1 KEY PLAN: TWISTER BAR AREA
 2.01 SCALE: 1/4" = 12" ARCH. REF.: 1/A450

blacks outsourcing, inc.
 Architectural Woodwork Engineering
 Our business is drawing yours

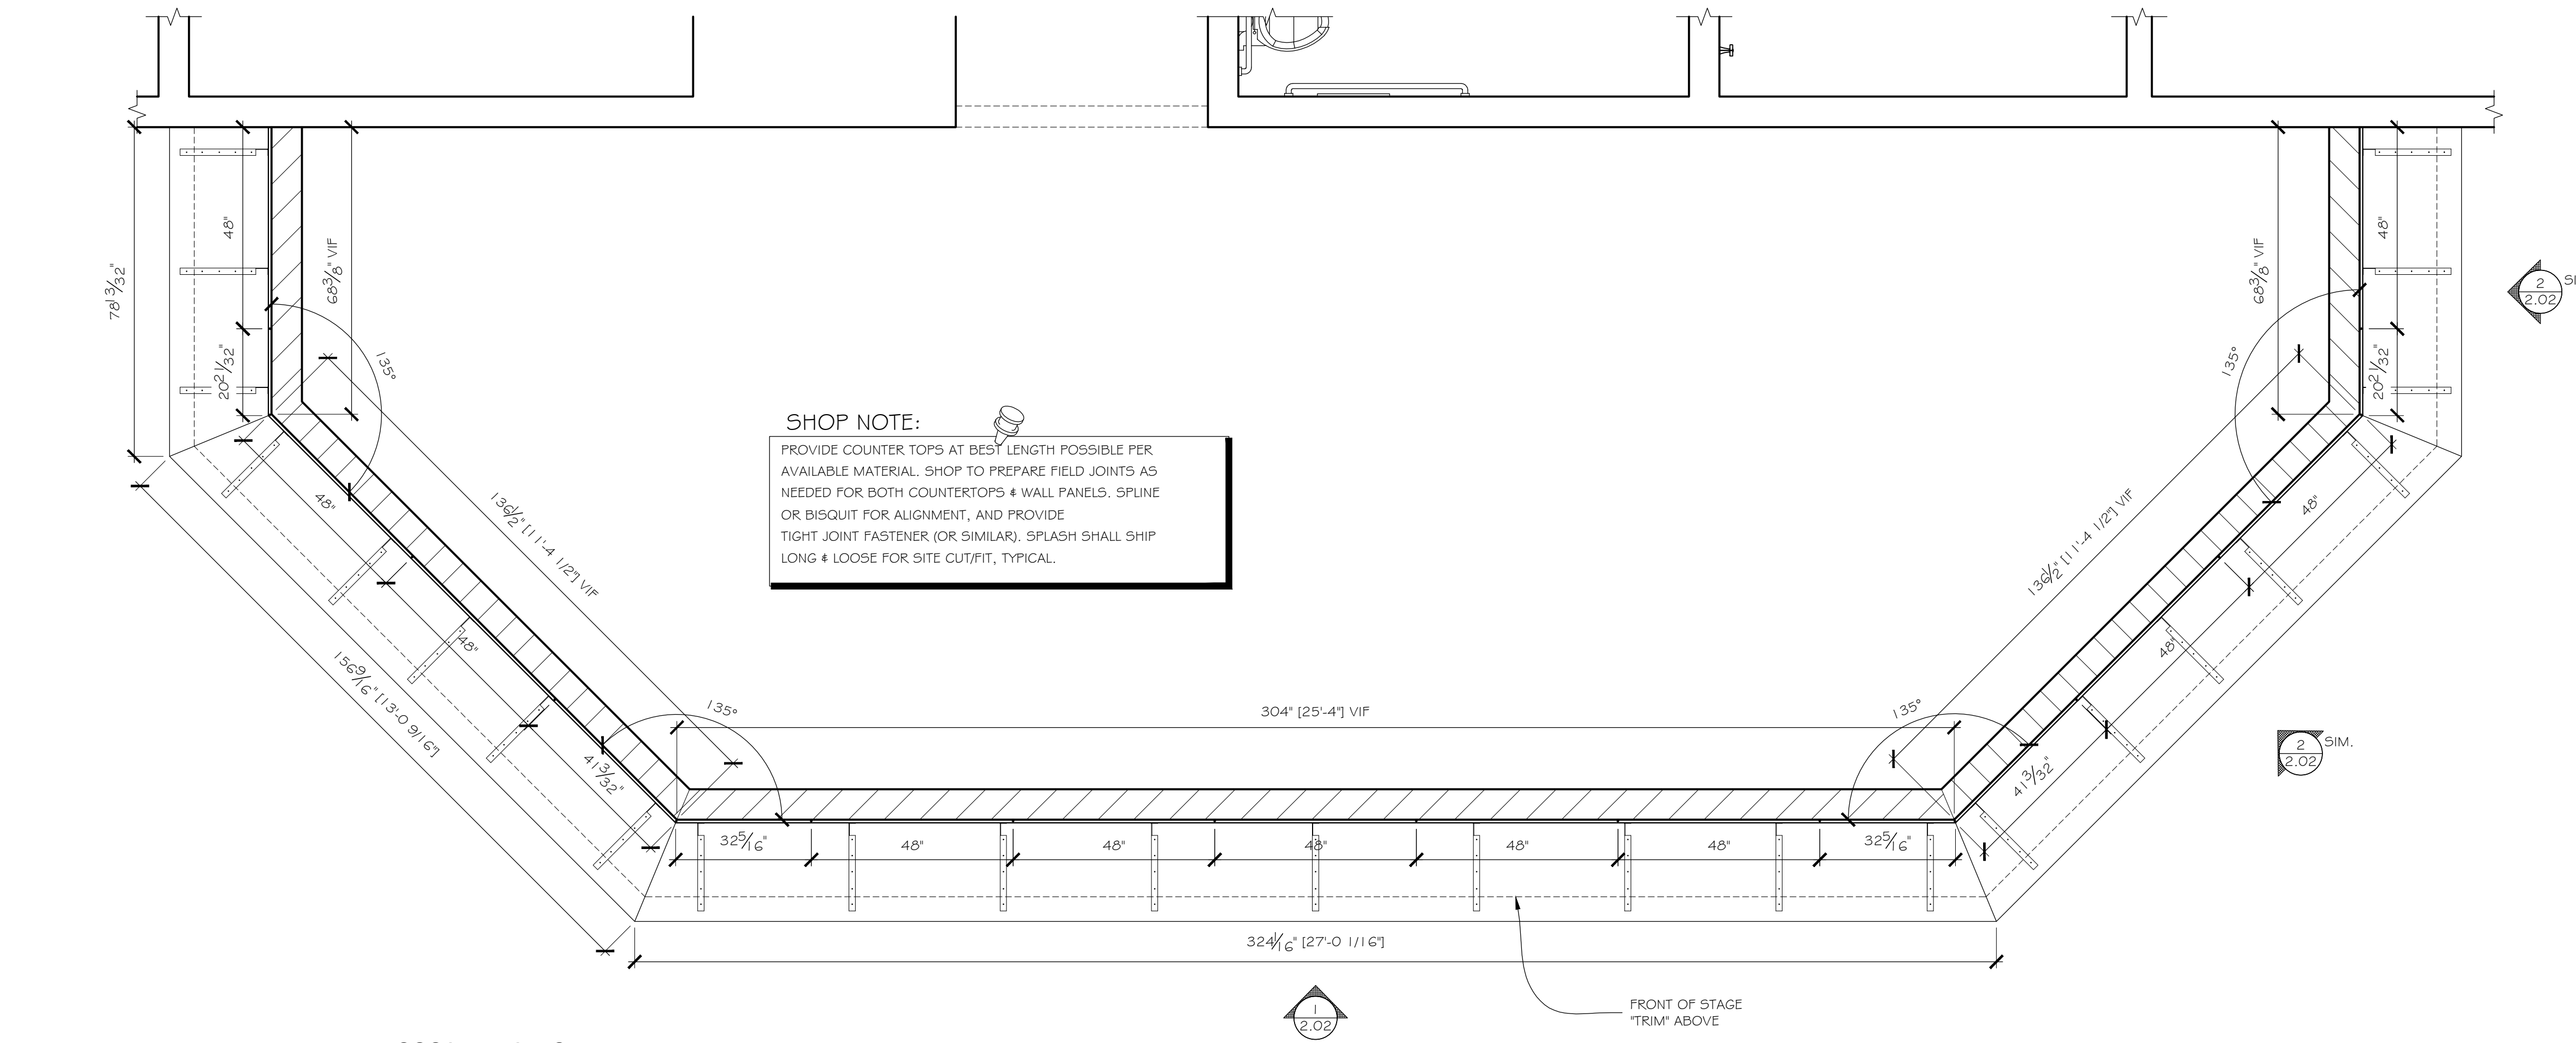
ARCHITECT:
 PLEASE NOTE THAT WOOD SYSTEMS INC HAS NO ITEMS IN SCOPE PER THE REFLECTED CEILING PLAN. ALL WOOD ITEMS AS SHOWN ON A201.04 ARE THEMED ITEMS, BY OTHERS.

2 DETAIL: STAGE CASING
 2.03 SCALE: FULL SCALE ARCH. REF.: NONE

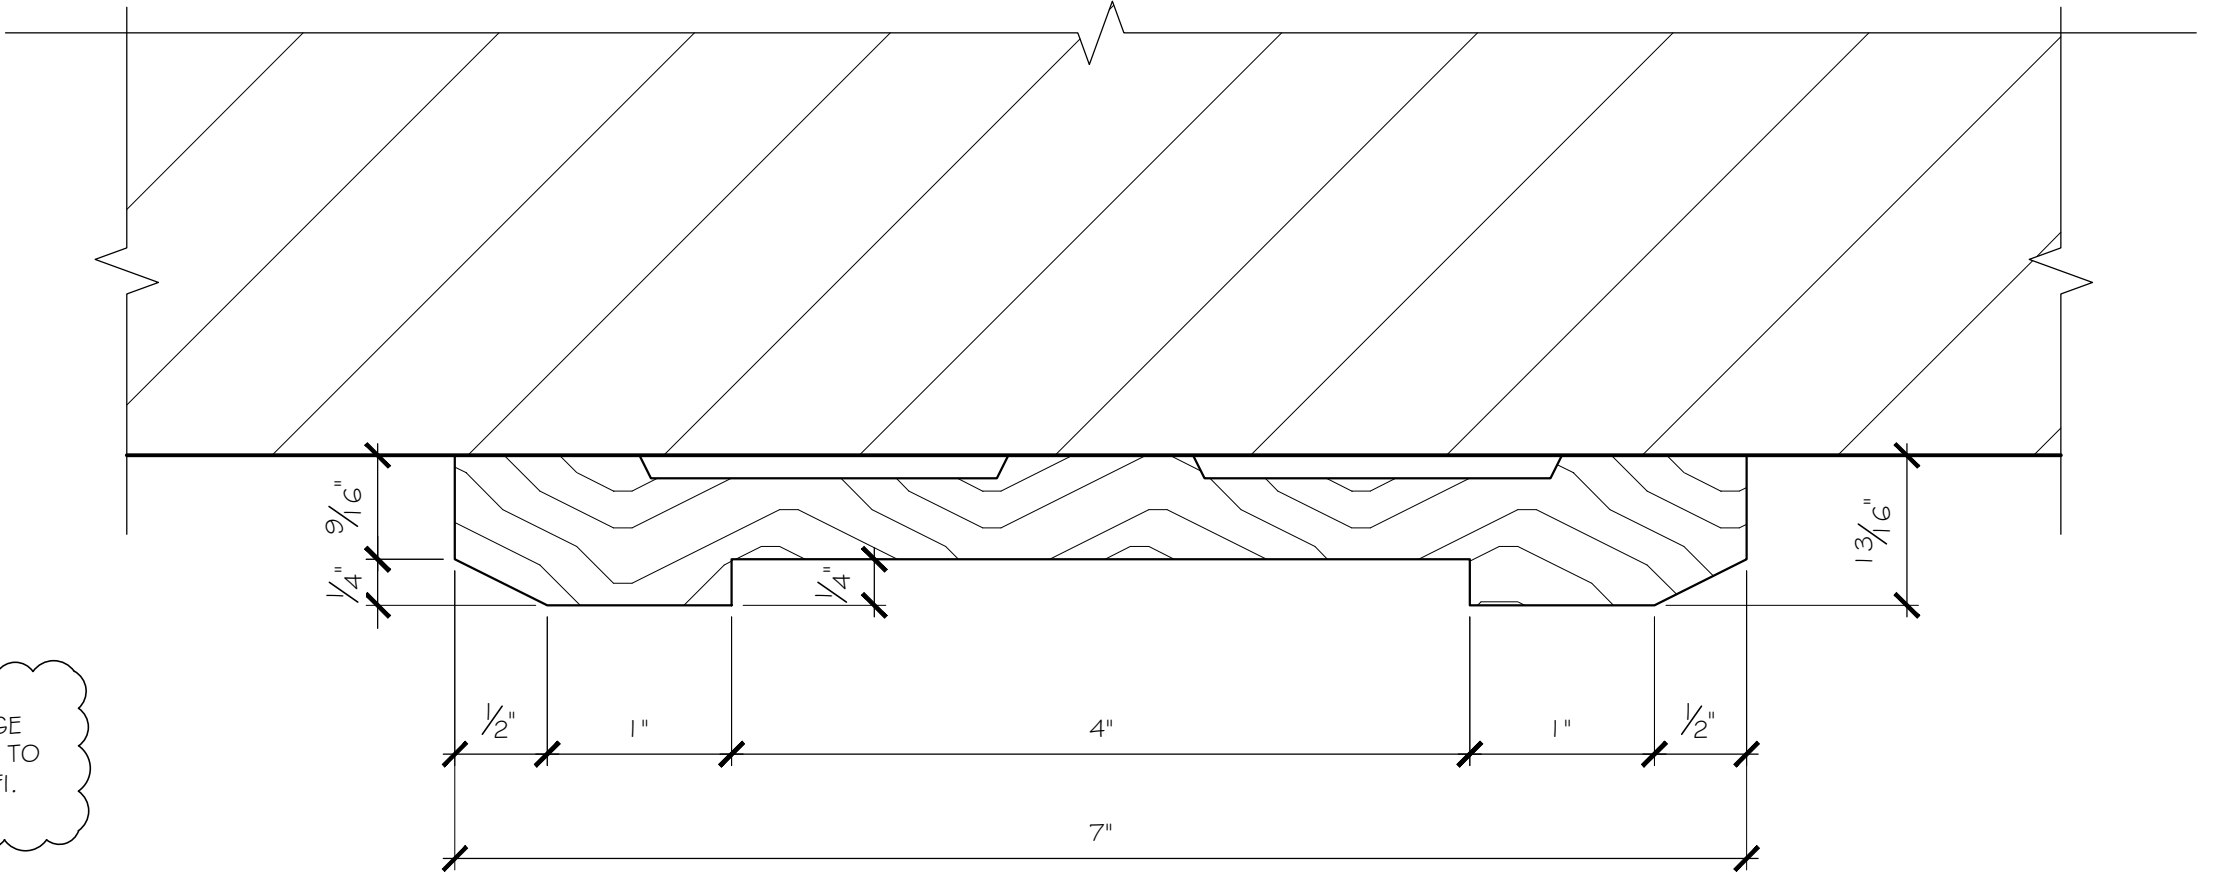
DETAIL MAY CHANGE PENDING RESPONSE TO WALL PANELING RFI.
